SUBJECT: PETROLEUM TECHNICAL ADVISORY MESSAGE # 79 - FUEL LINE ELBOW ON ALL M978 HEAVY EXPANDED TACTICAL TRUCK (HEMTT) TANKERS.

SUBJECT: SAFETY OF USE MESSAGE (SOM), TACOM CONTROL NO. 94-07,
"TECHNICAL," FOLLOW-UP INSPECTION OF THE FUEL PIPE ELBOW ON ALL M978
HEAVY EXPANDED MOBILITY TACTICAL TRUCKS (HEMTT) TANKERS, NSN
2320-01-097-0249, LIN T58161 (TRUCK, TANK, FUEL W/O WINCH) AND NSN
2320-01-100-7672, LIN T87243 (TRUCK, TANK, FUEL W/WINCH).

Appendix E

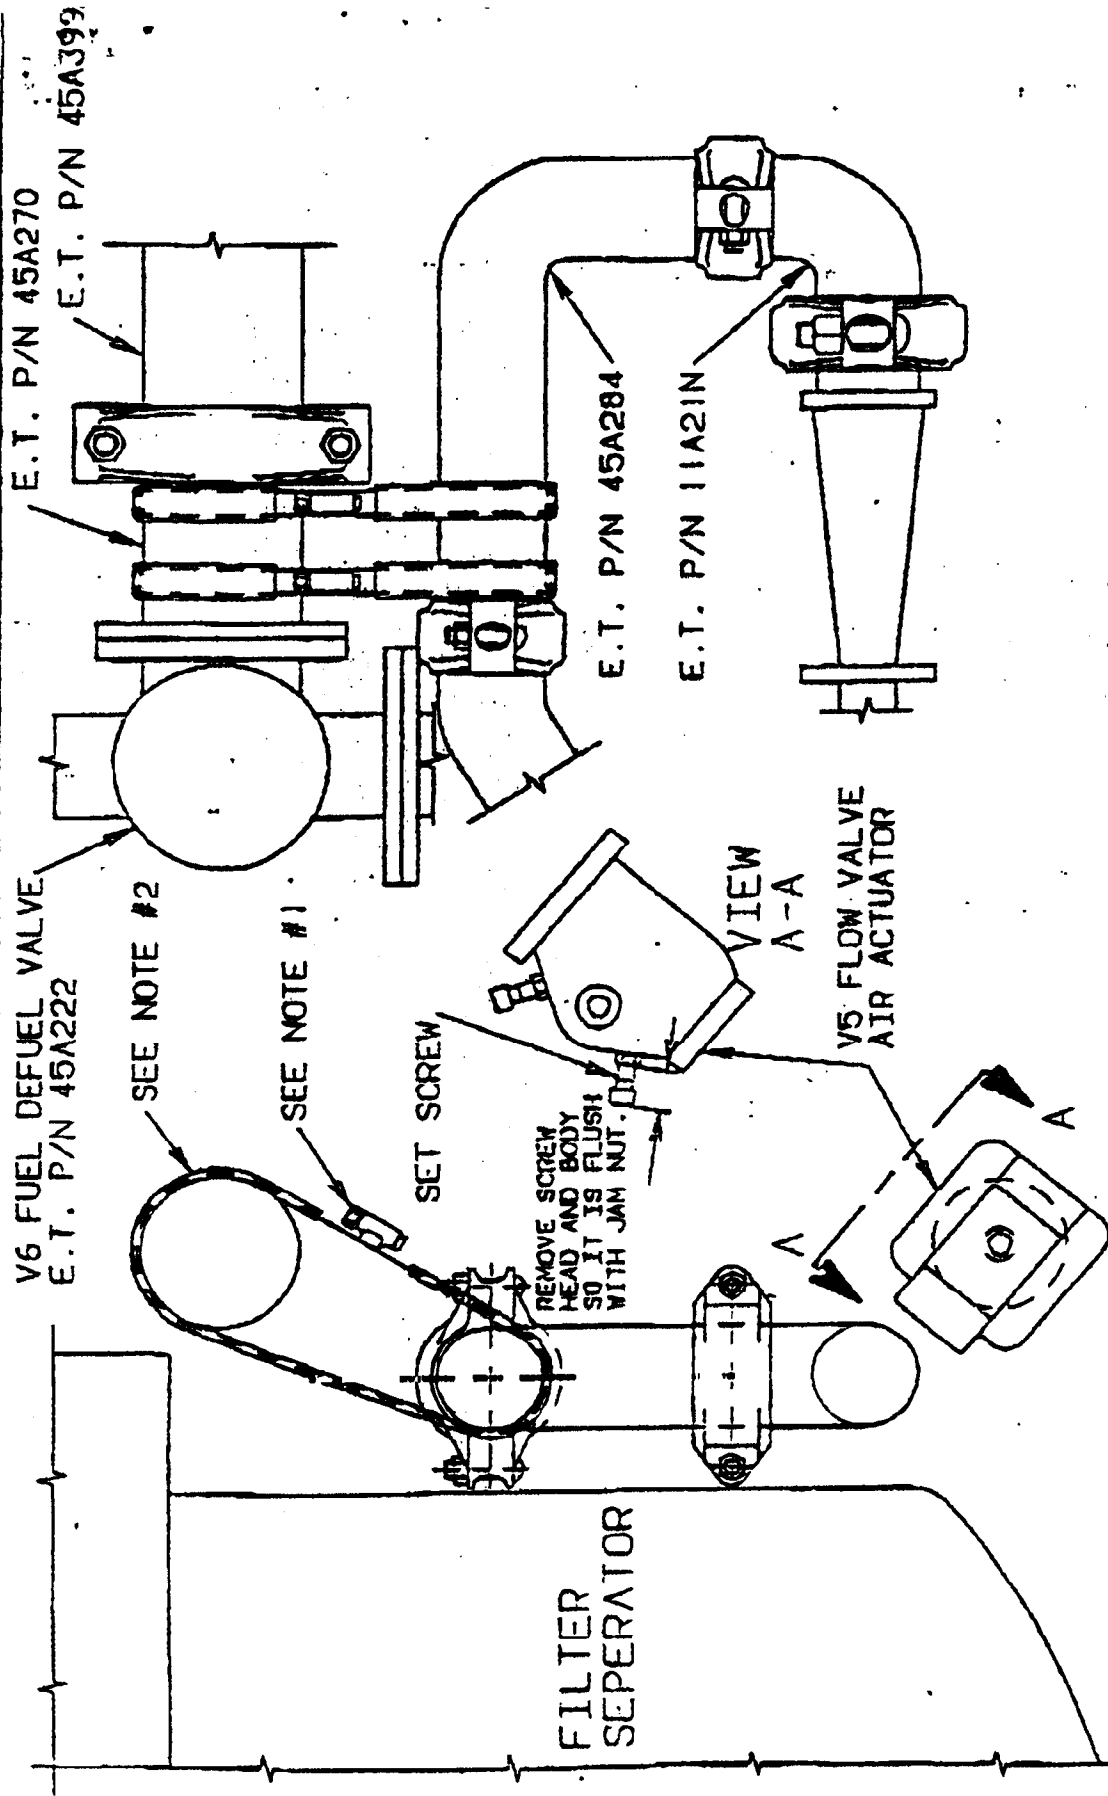
* F. REQUISITION 2 HOSE CLAMPS (NSN 4730-01-280-8502) AND TUBING
 * (NSN 4720-01-353-7464). INSTALL 27 INCHES OF THE TUBING ONTO
 * EACH HOSE CLAMP.

* G. USE THE 2 HOSE CLAMPS TO CONNECT THE STRAIGHT ADAPTER, ITEM
 * 62 (REFER TO TM9-2320-279-20P, FIG 310, SHEET 3 OF 6) TO PIPE
 * ELBOW, ITEM 46 (REFER TO TM9-2320-279-20P, FIG 310, SHEET 2 OF 6)
 * BY PLACING THE HOSE CLAMPS AROUND THE STRAIGHT ADAPTER, ITEM 62,
 * AND THE HORIZONTAL PORTION OF PIPE ELBOW, ITEM 46. DO "NOT"
 * TIGHTEN THE HOSE CLAMPS AT THIS TIME.

1. BREEZE INDUSTRIAL PRODUCTS AERO-SEAL HOSE CLAMP P/N 200152.
7.12 - 10.00 EFFECTIVE DIAMETER RANGE.

2. PARKER P/N FV108-1 .62 OD X .50 ID X 27" CLEAR VINYL TUBING.
NSN 4730-01-353-7464
